Design Review Board
Carlyle Plaza Two: Hotel/Residential Site

Application	General Data	
<p>Project Name: Carlyle Plaza Two – Master Plan and DSUP Amendments</p> <p>Location: 760 John Carlyle Street</p> <p>Applicant: Carlyle Plaza LLC , represented by Shalom Baranes Architects</p>	DRB Date:	July 16 , 2015
	Site Area (total project area):	6.23 acres
	Zone:	CDD#11
	Proposed Use:	Hotel and Residential
	Approved Gross Floor Area (total project area):	632,056 sf – Residential 755,114 sf – Office (with allowance for conversion of up to 250,000 sf to Hotel and 125,000 sf to additional Residential) 1,387,170 sf – Total
Purpose of Application:		
Request for DRB review of a phasing and massing study for the Carlyle Plaza Two plan, including a hotel/residential building to replace one of the approved office towers.		
Staff Reviewers: Thomas H. Canfield, AIA tom.canfield@alexandriava.gov Robert Kerns, AICP, robert.kerns@alexandriava.gov Gary Wagner, RLA, gary.wagner@alexandriava.gov Jim Roberts, james.roberts@alexandriava.gov

Tower Location Zone and Building Heights

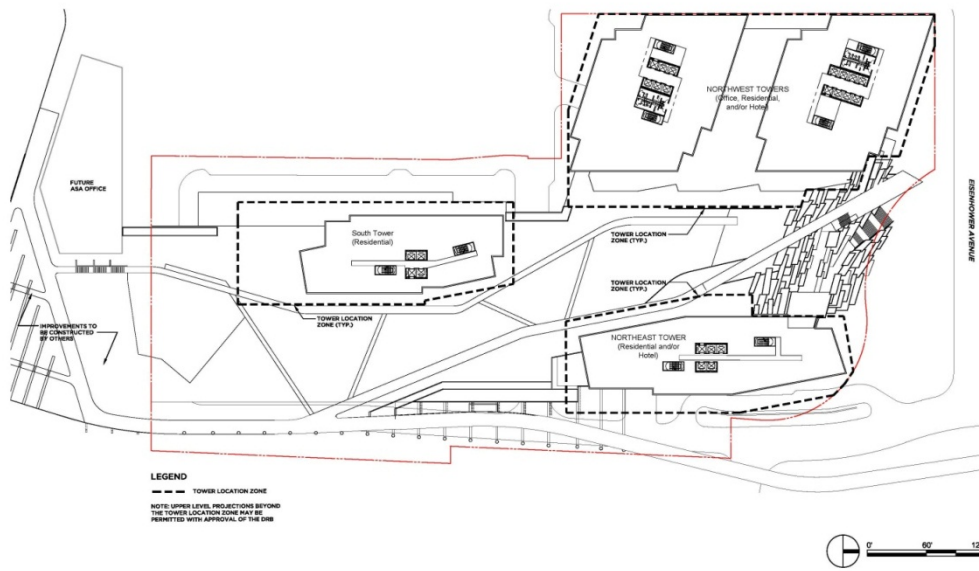
The tower location zone envelope set at the project approval is largely adhered to under the current proposal, although both the north residential tower and office tower appear to have some floors which exceed the envelope, which would require additional verification and possible revision by the applicant.
